Subject: Response to Request for Additional Information  
Related to Fall 2011 Steam Generator Tube Inservice Inspections  
Arkansas Nuclear One - Unit 1  
Docket No. 50-313  
License No. DPR-51

**Response to Request for Additional Information  
Regarding the Steam Generator Tube Inservice Inspection  
Fall 2011 Refueling Outage**

TAC NO. ME8279

**SG B Location of Tube with 3 Wear Scars**

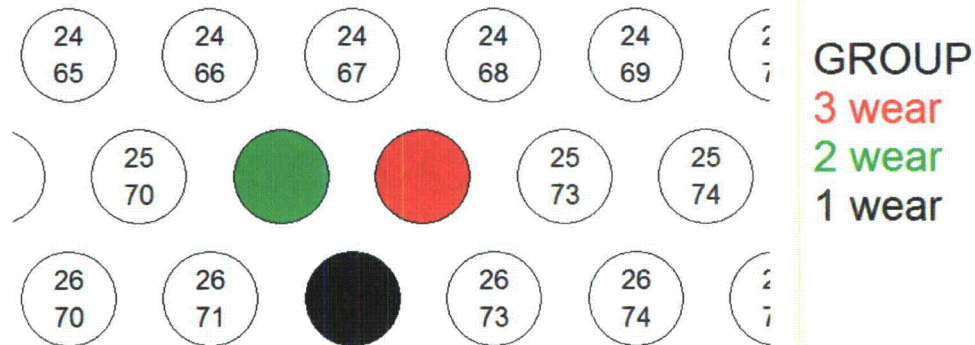
**6. One tube had three indications of wear attributed to tube-to-tube contact. In order for this to occur, the tubes involved would have to move in different directions to affect the tube in the middle.**

The 1R23 Condition Monitoring Operational Assessment (CMOA) (AREVA document 51-9173653-002) identified two locations with three wear scars, both in SG B (21-47 and 25-72). Note that this identification was made after re-analysis was performed on prior inspection data from 1R20 and 1R21 as well 1R23 based on limited number of tubes with Array or +Point data.

The initial planned 1R24 SG B eddy current inspections are complete. Inspections using qualified array techniques have identified one tube with TTW indications. The tube SG B R25 T72 has 3 wear scars and is shown below. The 1R24 inspections were performed for tie rod bowing phenomena. These inspections included tubes with previous TTW indications but not adjacent tubing. Adjacent tubing to R25 T72 could have TTW and currently would remain uninspected.

Testing of adjacent tubing to R25 T72 will be performed with the Array Probe.
